EARLY DESIGN GUIDANCE OF THE QUEEN ANNE/ MAGNOLIA DESIGN REVIEW BOARD

Project Number: 3012431

Address: 416 John Street

Date of Meeting: Wednesday, October 05, 2011

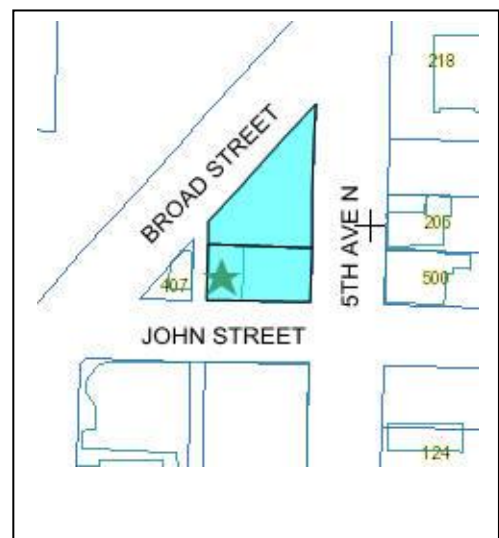
Three massing options were presented which varied the location and size of cut out used to provide light and air to internal facing residential units. One option had an entirely interior light well with building mass around it in a “doughnut” shape. The other two options utilized “C” shaped building structures above the podium base story, having a larger area of open space on the lid than the other. The applicants also showed three options for configuration of vehicular access, drop off space and loading docks. Two of the access plans utilized vehicle access points from both 5th Ave. and John St. and the third took access only from John St. but required an internal “hammerhead” turning space to allow vehicles to turn around to leave after dropping off at the lobby or using the ADA space.

The Board observed that the courtyard location could have many forms. It should respond to site conditions, namely buildings on two sides and an "amazing open space" at Seattle Center on another. It asked, what are the options for the courtyard? What direction should it face?

When considering the best place for vehicle entry, the Board encouraged the applicants to consider the alley. If an internal auto court with street access is to be created the Board indicated the street to use for access would be John St. with one possible configuration having an entry from John St. and an exist to the alley.

The Board indicated if a curb side drop off area is to be incorporated, Broad Street should be considered as a strong candidate because Fifth Ave. is complicated by the presence of the overhead Monorail with support pillars in the right of way along the proposal site. John St. they said would be another possibility for curb side drop off. The Board asked that this issue be studied and a resolution shown at the next Design Review meeting.
